# Access Compliance Report

## Public Rights-of-Way

### (Pedestrian Signals)

Intersection ID: N/A	Main Street:	Cross Street: N/A	Location: N/A
ADA ID: B1DB944AA1A2	Signal Type: One Push Button-Non APS	Overall Compliance: No	Severity Score: BTN 1: N/A BTN 2: N/A No BTN: N/A
Codes/Mitigation Info/Possible Solution		Field Measurements/Component Compliance

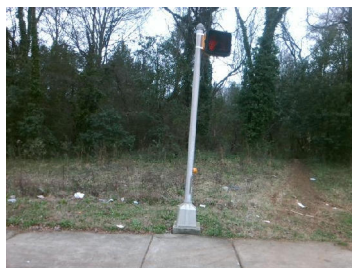
PROW/ADA: TMUTCD 4e.08, R404.7.2

N/A	B 1 FWD Approach Width (in)	N/A	N/A	B 2 FWD Approach Width (in)	N/A
N/A	B 1 FWD Approach Obstruction?	Yes	N/A	B 2 FWD Approach Obstruction?	N/A
N/A	B 1 FWD Approach Obstruction Dist (in)	5.0	N/A	B 2 FWD Approach ObstructionDist (in)	N/A
N/A	B 1 PARA Approach?	Yes	N/A	B 2 PARA Approach?	N/A
N/A	B 1 PARA Approach Constrained?	Yes	N/A	B 2 PARA Approach Constrained?	N/A
Yes	B 1 PARA Approach Reach (in)	7.0	N/A	B 2 PARA Approach Reach (in)	N/A
No	B 1 PARA Approach Width (in)	48.0	N/A	B 2 PARA Approach Width (in)	N/A
N/A	B 1 PARA Approach Obstruction?	Yes	N/A	B 2 PARA Approach Obstruction?	N/A
N/A	B 1 PARA Approach Obstruction Dist (in)	6.0	N/A	B 2 PARA Approach ObstructionDist (in)	N/A
Yes	B 1 Clear Floor Space Slope (%)	0.8	N/A	B 2 Clear Floor Space Slope (%)	N/A
Yes	B 1 Clear Floor Space XSlope (%)	1.0	N/A	B 2 Clear Floor Space XSlope (%)	N/A
N/A	B 1 PAR Slope (%)	N/A	N/A	B 2 PAR Slope (%)	N/A
Yes	B 1 Height (in)	40.0	N/A	B 2 Height (in)	N/A

N/A	B 1 Clear Xing Direction?	Yes	N/A	B 2 Clear Xing Direction?	N/A
	B 1 Crossing Direction	To N		B 2 Crossing Direction	N/A
Yes	B 1 DistanceTo XWalk (in)	48.0	N/A	B 2 DistanceTo XWalk (in)	N/A
No	B 1 DistanceTo Curb (in)	147.0	N/A	B 2 DistanceTo Curb (in)	N/A
Yes	B 1 Diameter (in)	2.0	N/A	B 2 Diameter (in)	N/A

Possible Solutions: Replace Signal Push Button With APS Button on New Post. Remove & Relocate Sign.
